Cashion Sketch Plan

PART 1: PROJECT SUMMARY

Property Address: 5917 Cashion Road

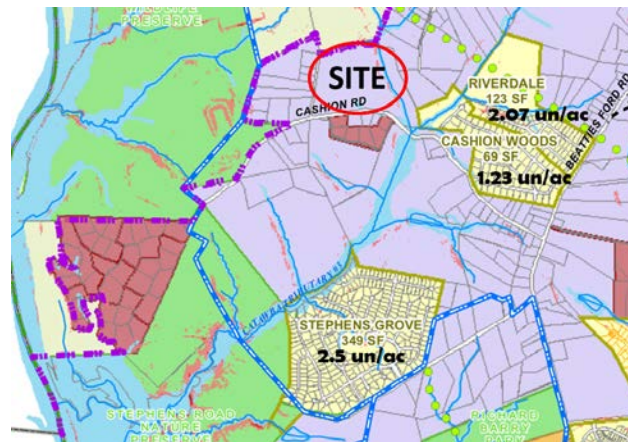
- **Policy T-8: Street Connectivity.** Promote and require street connectivity in the Town of Huntersville among residential, commercial, employment, recreational and institutional uses.

STAFF COMMENT: The proposed development has two separate entrances from Cashion Road. Internal to the subdivision a stub street located on the western property line will provide a right of way extending to Linderman Street (private easement) to provide for future connectivity. A connection to the east, due to the creek provides restraints. A connection to the north into Duke Energy property was not warranted, but the developer has extended the right-of-way to the property line to provide for future connectivity should development occur. The developer, as called for in Beatties Ford Corridor Plan, is reserving area within the southeast corner of the subdivision to allow for a north-south collector street.
